# Work Order ID 108698

Item Name: Crosstube Turning Detail

<b>DART AEROSPACE LTD</b>	<b>Work Order:</b>	108698
<b>Description:</b> Crosstube Assembly (205/212/412 High Fwd)	<b>Part Number:</b>	D212-664-141
<b>Inspection Dwg:</b> D212-664-141 <b>Rev:</b> D		<b>Page 1 of 2</b>

DRAWING NO. D212-664-141	TITLE XTUBE ASSY (205/212/412 HI FWD)	REV. D	<b>DART AEROSPACE LTD ENGINEERING ORDER</b>	D.E.O. NO. D212-664-141-D-1	SHEET NO. SHEET 1 OF 2	SCALE NTS
DRAWN	CHECKED	MP	MFG. APPR.	APPROVED	DE APPR.	
DATE 11.04.07	DATE 11.04.11		DATE 11.04.12	DATE 11/04/12	DATE 11.04.12

**D212-664-141/-141B  
ASSEMBLY DETAIL**

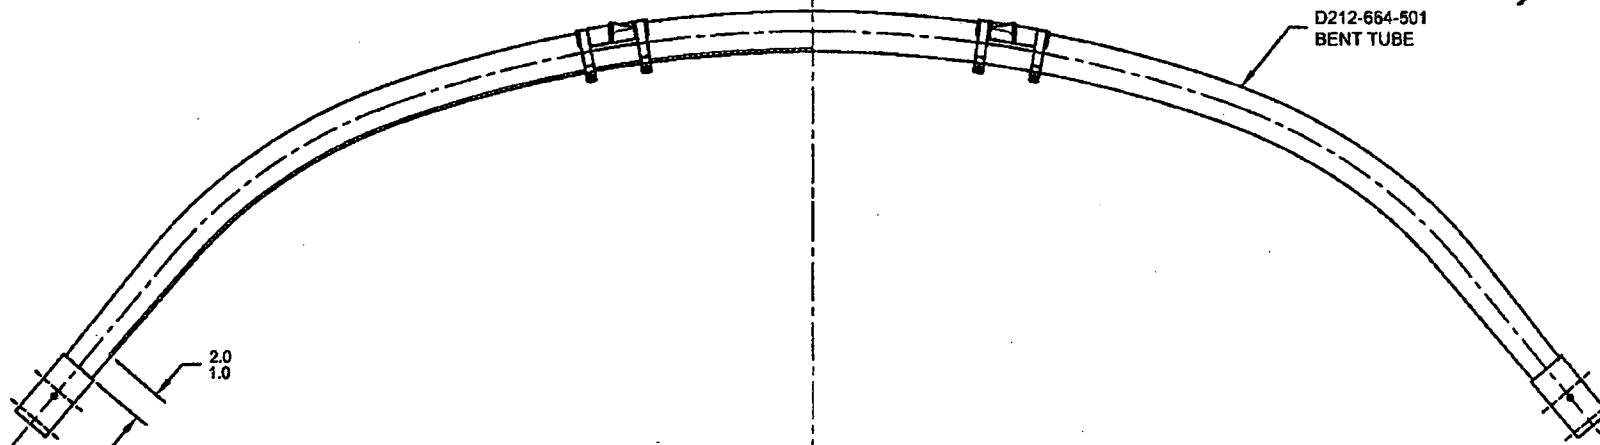
ADD AN INSPECTION WINDOW TO UNDERSIDE OF CROSSTUBE.

- 2) FINISH: CHEMICAL CONVERSION COAT PER DART QSI 005 4.1  
PRIME INSIDE AND OUTSIDE PER DART QSI 005 4.2  
MASK UNDERSIDE OF CROSSTUBE AS SHOWN (HATCHED AREA) AND  
PAINT OUTSIDE PER DART QSI 005 4.2  
REMOVE MASKING AND APPLY CLEAR COAT

- 2) FINISH: CHEMICAL CONVERSION COAT PER DART QSI 005 4.1  
PRIME INSIDE AND OUTSIDE PER DART QSI 005 4.2  
PAINT OUTSIDE PER DART QSI 005 4.2

MASK AREA PRIOR TO PAINTING.  
REMOVE MASKING AFTER PAINT  
AND APPLY CLEAR COAT
